DOMUSEA DEVELOPMENTS
PROPOSED RESIDENTIAL ACCESS
ARRANGEMENTS
CLAYS FARM, NORTH END ROAD,
YAPTON, SUSSEX

REPEAT STAGE 1 - ROAD SAFETY
AUDIT

JUNE 2021

Report title:	Domusea Developments Proposed Residential Access Arrangements Clays Farm, North End Road, Yapton, Sussex Repeat Stage 1 - Road Safety Audit
Date:	June 2021
Document reference and revision:	S/DDNorthendRoad.R1.6 Rev A
Prepared by:	Martyn Parr - Mayer Brown Ltd
Approved by:	John Reid - Mayer Brown Ltd
On behalf of:	Domusea Developments
Status:	Final

MBSK210525-04

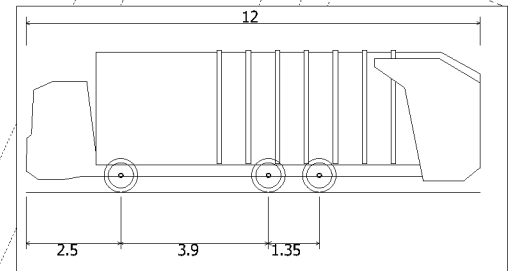
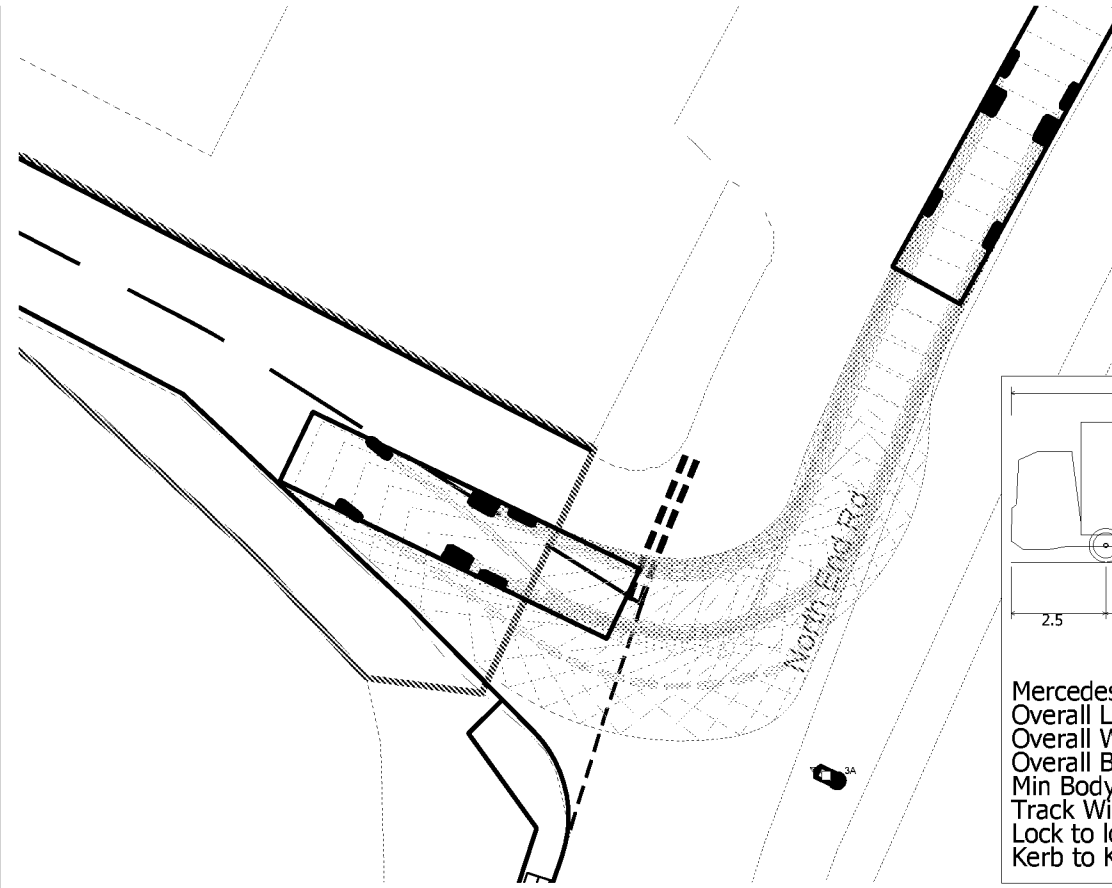
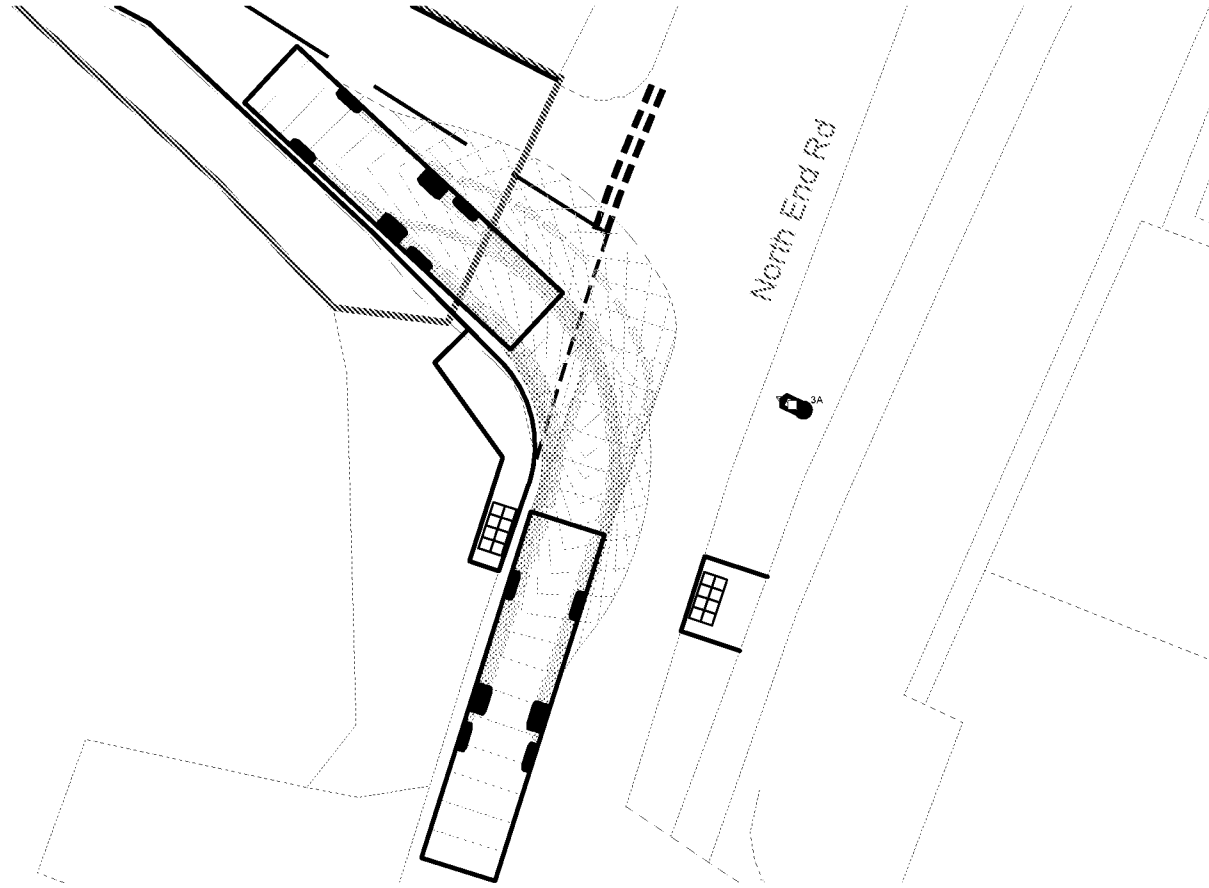
Summary: Visibility splay - Obstruction

Whilst visibility splays have been formally identified on the drawings submitted, it will be important that these splays remain free from obstruction.

Location: Site Access Road/North End Road (please refer to reference points 3.1 in Appendix B).

Summary: Dropped kerbs should be provided on the pedestrian desire lines.

It will be important to provide dropped kerbs on all pedestrian desire lines to ensure continuity of the pedestrian route. Failure to do so may result in pedestrians, especially the vision and mobility impaired, tripping on kerbs, or unable to access the footways.

It is recommended that junction visibility splays detailed on the drawing MBSK210525-04-P2 will be kept free from obstruction. Any vegetation within the splays should be maintained to ensure that it does not extend beyond a vertical height of 0.6m.

It is recommended that dropped kerbs are provided on the pedestrian desire lines. Dropped kerbs should have an upstand of between 1-6mm.

SWEPT PATH ANALYSIS
REFUSE VEHICLE ENTERING/EXITING SITE

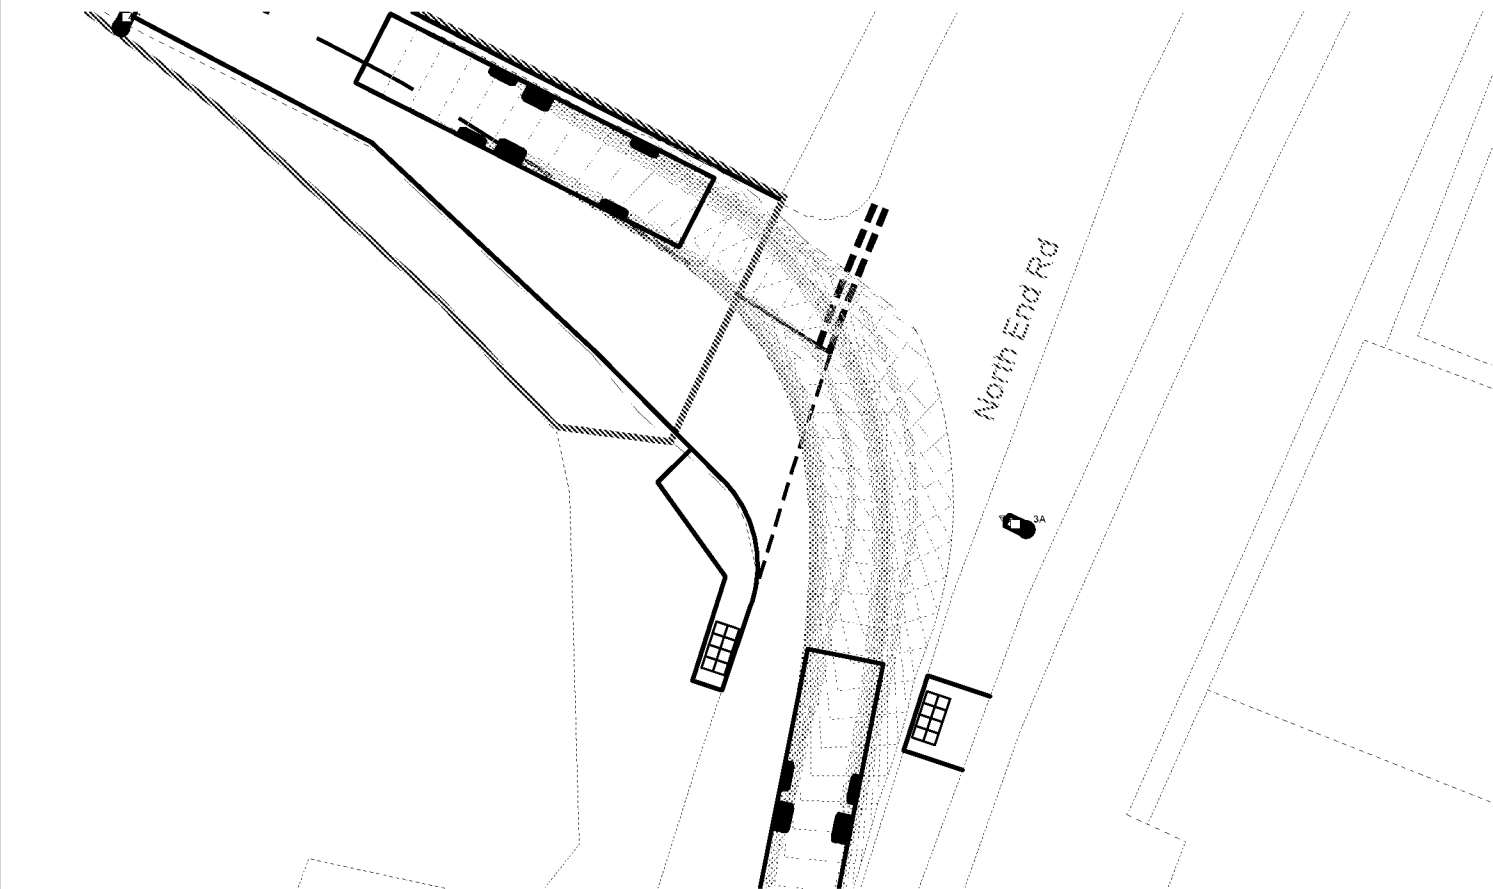
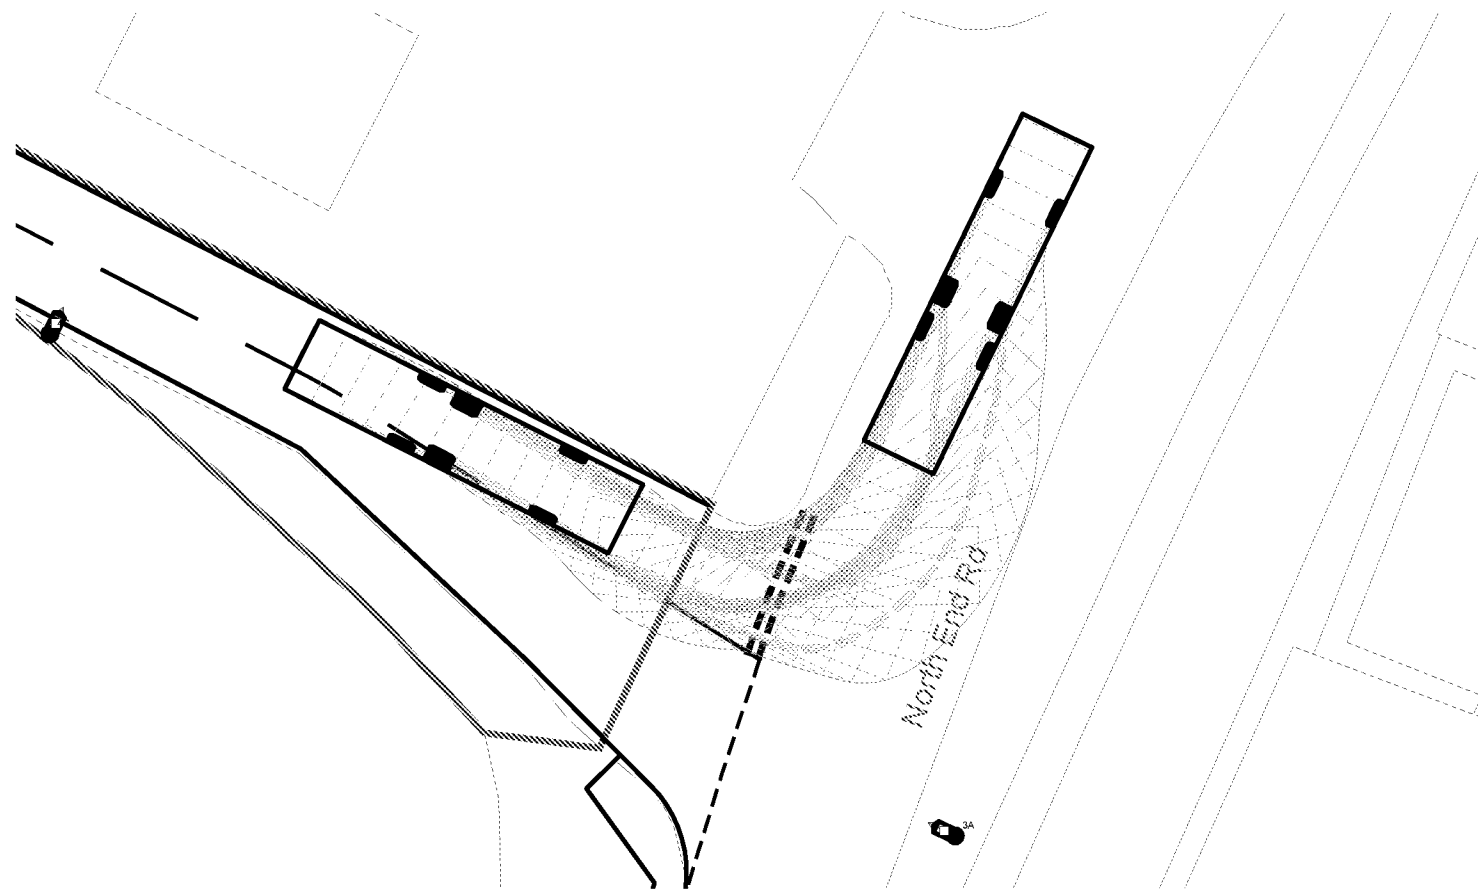
Summary: Servicing Arrangements.

It is important that a refuse vehicle can access the site appropriately without traversing the footway or requiring excessive reversing manoeuvres. The vehicle should be able to leave the site in a forward gear.

It is recommended that swept path analysis is undertaken within the development site using a refuse vehicle to ensure that the vehicle can egress the site in a forward gear.
